ZHL-2-12+ PCN Report

AN-60-068

ORIGINAL PART: ZHL-2-12

REPLACEMENT PART: ZHL-2-12+

3) TYPICAL PERFORMANCE COMPARISON_a: T_{AMB}=25°C

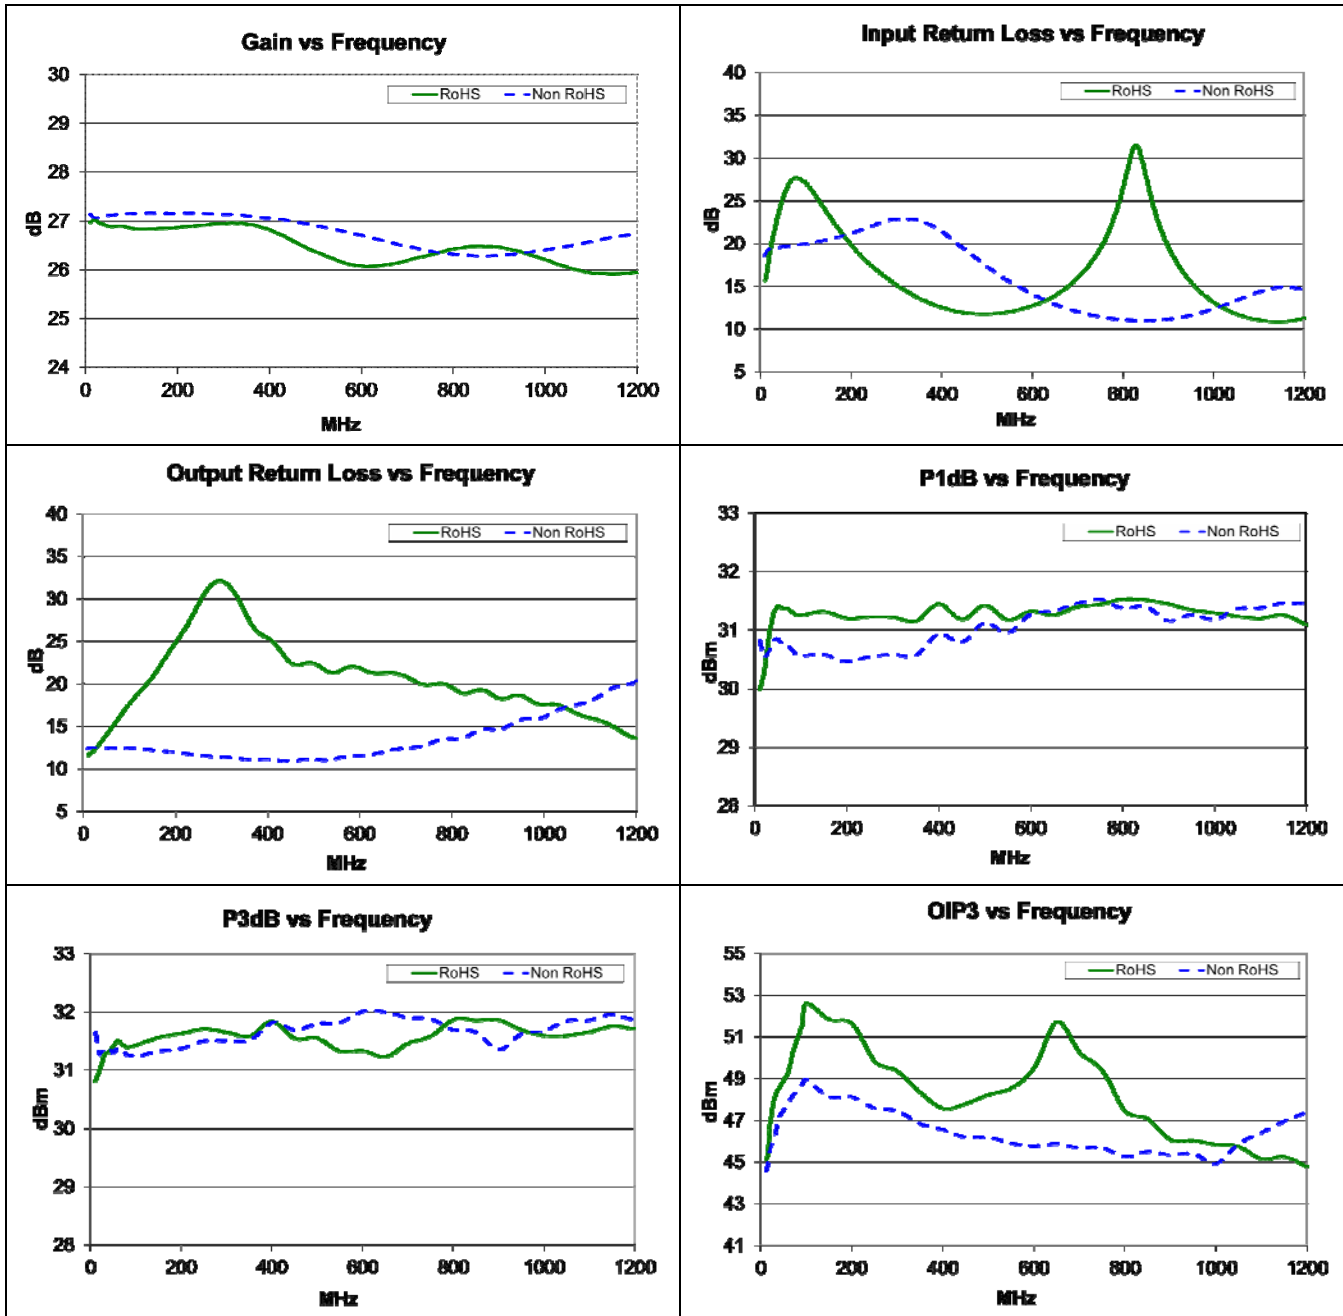
Parameter	Freq (MHz)	Non RoHS		RoHS	
		Min	Max	Min	Max
Gain (dB)	10-1200	26.29	27.16	25.73	27.06
Gain Flatness (dB)	10-1200	-----	+/-0.43	-----	+/-0.67
Input VSWR (:1)	10-1200	-----	1.78	-----	1.8
Output VSWR (:1)	10-1200	-----	1.8	-----	1.72
Pout 1dB (dBm)	10-1200	30.47	-----	29.99	-----
Pout 3dB (dBm)	10-1200	31.24	-----	30.82	-----
OIP3 (dBm)	10-1200	44.57	-----	44.77	-----
Noise Figure (dB)	10-1200	-----	4.9	-----	5.34
DC Voltage (V)	-----	-----	24	-----	24
Supply Current (A)	-----	-----	0.48	-----	0.56

COMPARISON PERFORMANCE CURVES^a: T_{AMB}=25°C

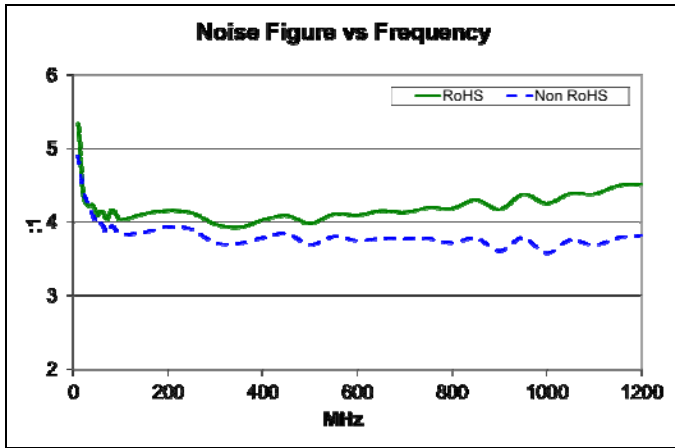
- 1) No change in FIT and FORM
- 2) Functional Changes as follows:

Parameter	Original Part, ZHL-2-12	Replacement Part, ZHL-2-12+
Gain Flatness	+/- 1 dB Max	+/-1.2dB max, +/-0.7dB typ
Input VSWR	2:1 max	2.2:1 max
Output VSWR	2:1 max	2.2:1 max
P1dB	+29dBm min* *+28.5dBm min at 1000-1200MHz	28dBm min, 29dBm typ
P3dB	N/A	29dBm min, 30dBm typ
Noise Figure	4dB typ** **Below 100MHz, Noise Figure increases to 16dB at 10MHz	5dB typ
OIP3	38dBm typ	45dBm typ
